Access Compliance Report

Public Rights-of-Way

Intersection ID: 9648	Main Street: TIMBERBROOK_DR	Cross Street: TUCKASEEGEE_RD	Location: SW
ADA ID: 734C5C5F1E4A	Ramp Type: Directional1	Initial Pass/Fail: Fail	Overall Compliance: No
		Severity Score: 1.25

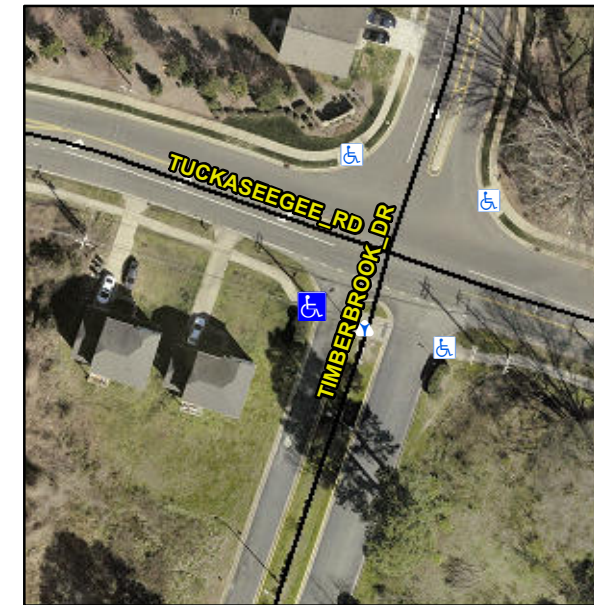
R304.5.3

Compliance	Description	Data	Compliance	Description	Data
N/A	Ramp Length (in)	62.0	N/A	Grade Break?	N/A
Yes	Ramp Width (in)	68.5	N/A	Grade Break Slope (%)	0.0
Yes	Ramp Slope (%)	6.3	N/A	Grade Break XSlope (%)	0.0
No	Ramp XSlope (%)	2.1			
N/A	Flare Type LT	N/A	N/A	Flare Type RT	N/A
N/A	Flare Slope LT (%)	N/A	N/A	Flare Slope RT (%)	0.0
N/A	Flare Traversable LT?	N/A	N/A	Flare Traversable RT?	N/A
N/A	Landing Length (in)	0.0	N/A	DWS Provided?	N/A
N/A	Landing Width (in)	0.0	N/A	DWS Contrast?	N/A
N/A	Landing Slope (%)	0.0	N/A	DWS Length (in)	N/A
N/A	Landing X Slope (%)	0.0	N/A	DWS Full Width?	N/A
N/A	Landing Curb? (Y/N)	N/A	N/A	DWS Offset LT (in)	N/A
N/A	Shared Landing?	N/A	N/A	DWS Offset RT (in)	N/A
N/A	Gutter Ponding?	0.0	N/A	Gutter Slope (%)	N/A
N/A	Gutter Lip Ht (in)	0.0	N/A	Gutter X Slope (%)	N/A
N/A	Painted X Walk1?	No		Road Slope (%)	5.3
	X Walk 1 Direction	To E		Road X Slope (%)	3.2
	X Walk 1 Width (in)	N/A		Clear Space?	N/A

Possible Solutions:

Remove & Replace Entire Ramp.
